Access Compliance Report

Public Rights-of-Way

Intersection ID: 45515	Main Street: COTTON_PRESS_RD	Cross Street: HEDGEROW_PARK_RD	Location: SE
ADA ID: D945D440E7C0	Ramp Type: PerpDiag	Initial Pass/Fail: Fail	Overall Compliance: No
Severity Score: 8.75			
Codes/Mitigation Info/Possible Solution		Field Measurements/Component Compliance

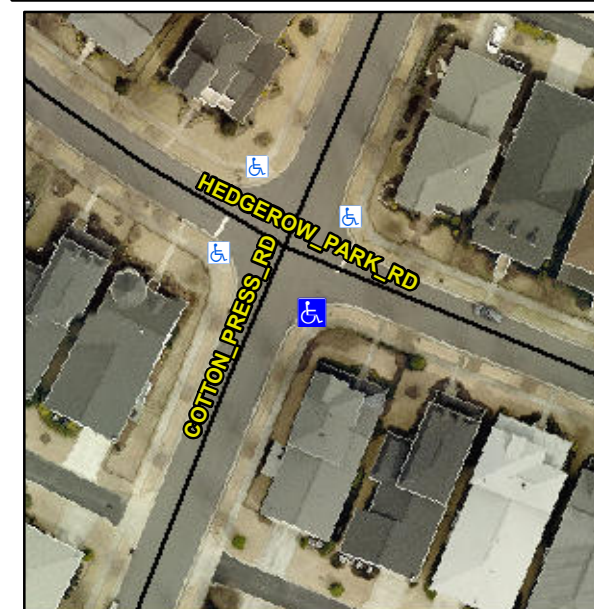
Remove & Replace Curb Ramp With Two New Directional Ramps or Equivalent.

R304.5.1

Compliance	Description	Data	Compliance	Description	Data
N/A	Ramp Length (in)	72.0	Yes	Ramp Slope (%)	7.8
No	Ramp Width (in)	44.0	Yes	Ramp XSlope (%)	1.9
N/A	Flare Type LT	N/A	N/A	Flare Type RT	N/A
N/A	Flare Slope LT (%)	N/A	N/A	Flare Slope RT (%)	N/A
N/A	Flare Traversable LT?	N/A	N/A	Flare Traversable RT?	N/A
N/A	Landing Length (in)	N/A	N/A	DWS Provided?	N/A
N/A	Landing Width (in)	N/A	N/A	DWS Contrast?	N/A
N/A	Landing Slope (%)	N/A	N/A	DWS Length (in)	N/A
N/A	Landing X Slope (%)	N/A	N/A	DWS Full Width?	N/A
N/A	Landing Curb? (Y/N)	N/A	N/A	DWS Offset (in)	N/A
N/A	Shared Landing?	N/A			
N/A	Gutter Ponding?	N/A	N/A	Gutter Slope (%)	N/A
N/A	Gutter Lip Ht (in)	N/A	N/A	Gutter X Slope (%)	N/A
N/A	Painted X Walk1?	No	N/A	Painted X Walk2?	No
	X Walk 1 Direction	To NE		X Walk 2 Direction	To NW
N/A	X Walk 1 Width (in)	N/A	N/A	X Walk 2 Width (in)	N/A
	X Walk 1 Slope (%)	1.7		X Walk 2 Slope (%)	2.0
	X Walk 1 X Slope (%)	2.3		X Walk 2 X Slope (%)	1.6
